[Docket No. FAA-2020-0883; Project Identifier 2019-CE-034-AD; Amendment 39-21460; AD 2021-05-17]

Airworthiness Directives; Rockwell Collins, Inc. Flight Display System Application

ACTION: Final rule.

Figure 1 to paragraph (g)(1)(iii); placard location on bezel

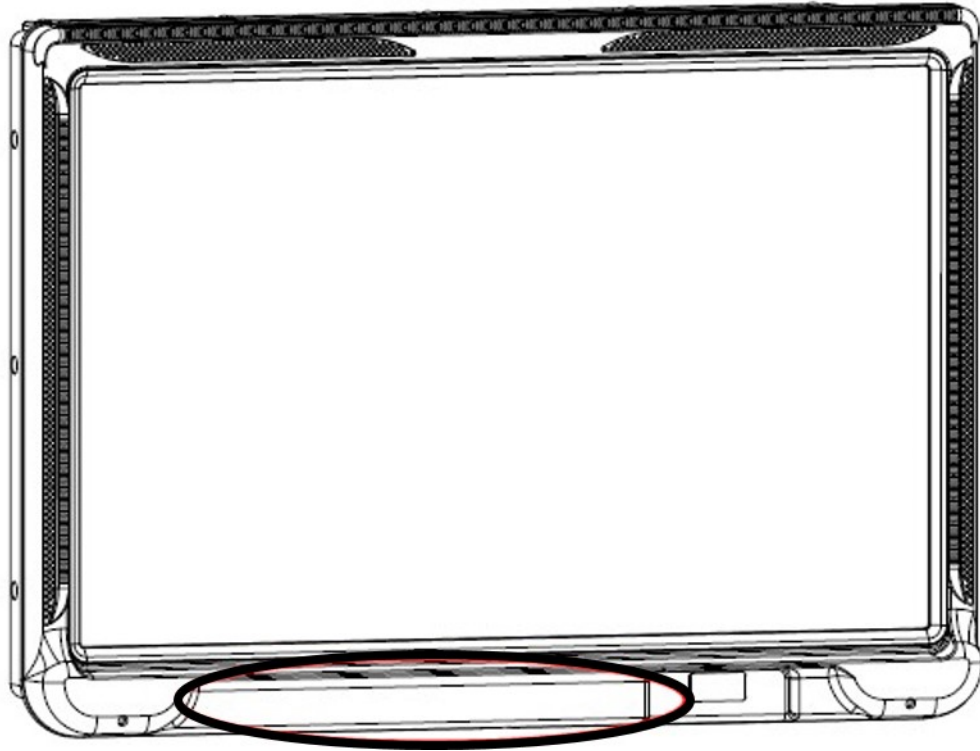
(ii) Fabricate a placard for each aircraft primary flight display, using at least 1/8 inch letters, with the following text: TCAS Flight Ops – TA Only mode (TA/RA mode prohibited).

(iii) Install the placard on the bottom of each aircraft primary flight display bezel in the area depicted in figure 1 to paragraph (g)(1)(iii) of this AD.
